APPLICATION NO.	FILING DATE	FIRST NAMED INVENTOR	ATTORNEY DOCKET NO.	CONFIRMATION NO.
10/666,865	09/18/2003	Min-Su Kim	5484-110	8456

<p align="center">Advisory Action Before the Filing of an Appeal Brief</p>	Application No. 10/666,865	Applicant(s) KIM, MIN-SU	
	Examiner Jennifer M. Dolan	Art Unit 2813

Continuation of 11. does NOT place the application in condition for allowance because:

Correspondence between figure 7B and figure 8B features

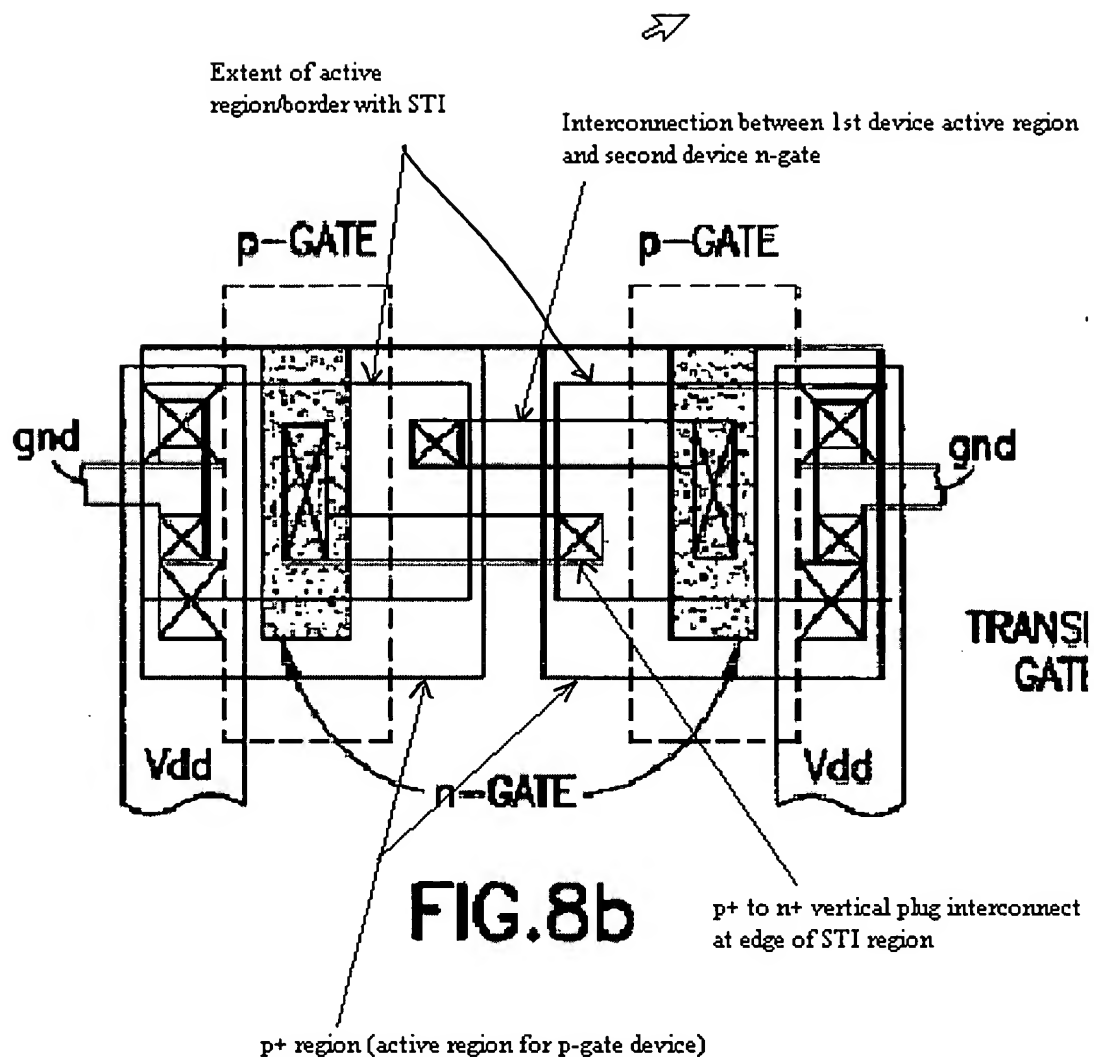
The Applicant further argues that the SOI layers are located entirely in the active region, and no part of the SOI is disposed in the device isolation area. Hence, "it is incorrect to interpret Assaderaghi's shallow trench isolation regions as being included in, or part of, the SOI layer." This is not persuasive, because Assaderaghi clearly shows the STI regions disposed within the exact same layer as the SOI regions. Hence, it would be considered normal and proper to state that the STI regions are formed in the SOI layer. Assaderaghi additionally indicates that the SOI substrate is provided, and then STI structures are provided in that SOI layer, preferably with the bottom of the STI extending to the top of the buried oxide layer (see column 5, lines 43-62). Furthermore, it is not particularly relevant whether the STI structures of Assaderaghi are considered to be inside the SOI layer, since Assaderaghi, when combined with Chen, provides a structure in which a portion of the SOI layer remains underneath the isolation structure.

The Applicant even further argues that the "left-most" n gate of fig. 8b is not disposed over the oxide isolation portion, and that it is not apparent in figure 8b where the active region is located. This is not persuasive, because the term "over" only requires that the feature be at a level higher than the active area and STI, rather than requiring any sort of overlap between the features. Furthermore, figure 7b directly shows and overlap between the n-gate and the active region. Similarly, since figures 7b and 8b show side and top views of the same area, it is apparent that the STI region includes an area directly under part of the n-gate (see attached figures).
